Sample Punch List

I visited the site on Tuesday to determine whether the landscape work was substantially complete and ready for the start of the 60 day maintenance period. My observations and comments follow:

LANDSCAPE CORRECTIONS - NORTH THE CORPORATE CENTER PHASE 2

SHEET NUMBER:
LC1

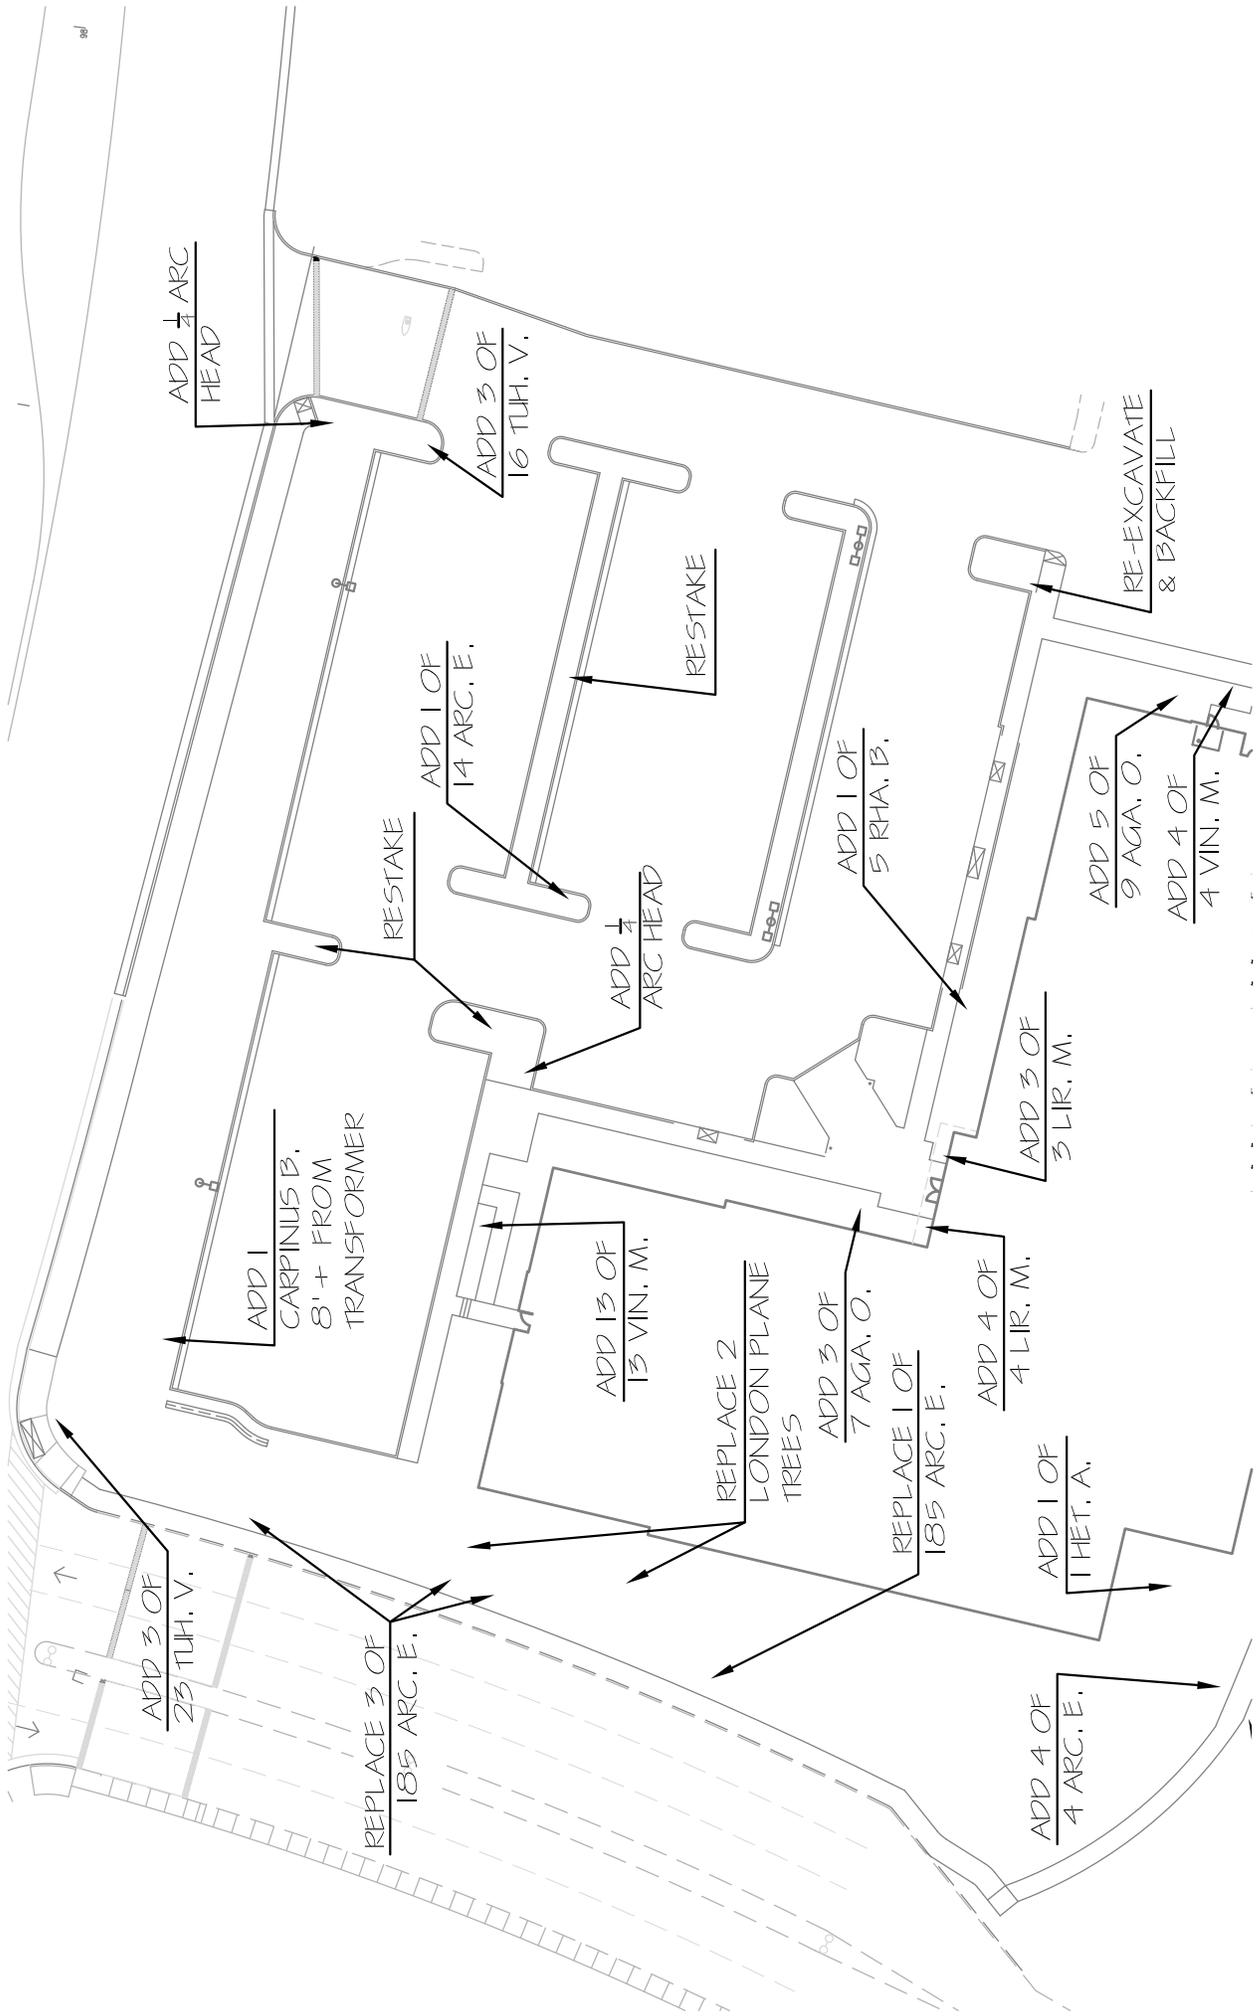
1. The planter soil in one planter (see the attached "Landscape Corrections" sheet) does not appear to meet the 24" minimum depth specified in Section 02920, Part 3 "Compacted Planting Areas". The planter must be excavated and backfilled with approved planting soil.
2. Some of the planter soil contains unacceptable amounts of large rocks and debris. Remove all rocks larger than 2 inches which are visible on the soil surface. See Specification Section 02920, Part 3 "Soil Preparation".

3. Pop-up sprinkler heights were not consistent with the Plan. All 6 inch pop-ups must be replaced where 12 inch pop-ups are specified.
4. Several spray heads shown on the Plan were missing and must be added. See the attached "Landscape Corrections" sheet.

3. The roots on 2 of the London Plane Trees are badly kinked near the root crown and indicate a potential for future problems. These trees must be replaced (see the attached "Landscape Corrections" sheet). Tree root balls must conform with the criteria of Specification Section 02950, Part 2 "Plant Materials".

- c. Tree stakes protruded well beyond the highest ties. Stake tops should be cut off 2 inches above the highest tree tie.
- E. Shrubs and Groundcover
1. The health of some of the shrubs did not appear to be satisfactory. All shrubs which are dead or in a state of decline must be replaced promptly. See Specification Section 02970, Part 3 "Trees, Shrubs and Groundcover" and the attached "Landscape Corrections" sheet.

2. Some discrepancies between shrub quantities on the Plan and in the field were noted. These discrepancies are noted on the "Landscape Corrections" sheet attached. Verify my field counts prior to ordering plants. Install the specified plants in the quantity delineated on the Planting Plan.
